Summary of public comments for Historic Preservation Commission meeting on March 23, 2022

Subject: Public Comment - Historic Preservation Commission - Agenda Item AR-

V FLOOR PLAN

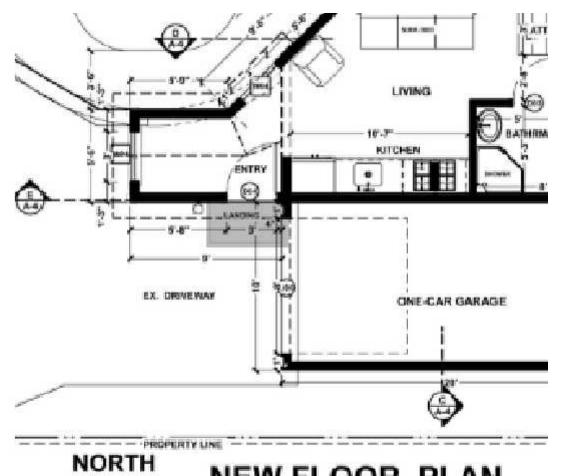
I think that the use of two types of siding and the addition of a pergola is a significant improvement over the original proposal.

I have a tiny concern that the landing for the entry appears to partially block the garage entrance. It is hard to see as the image embedded in the PDF becomes fuzzy when enlarged.
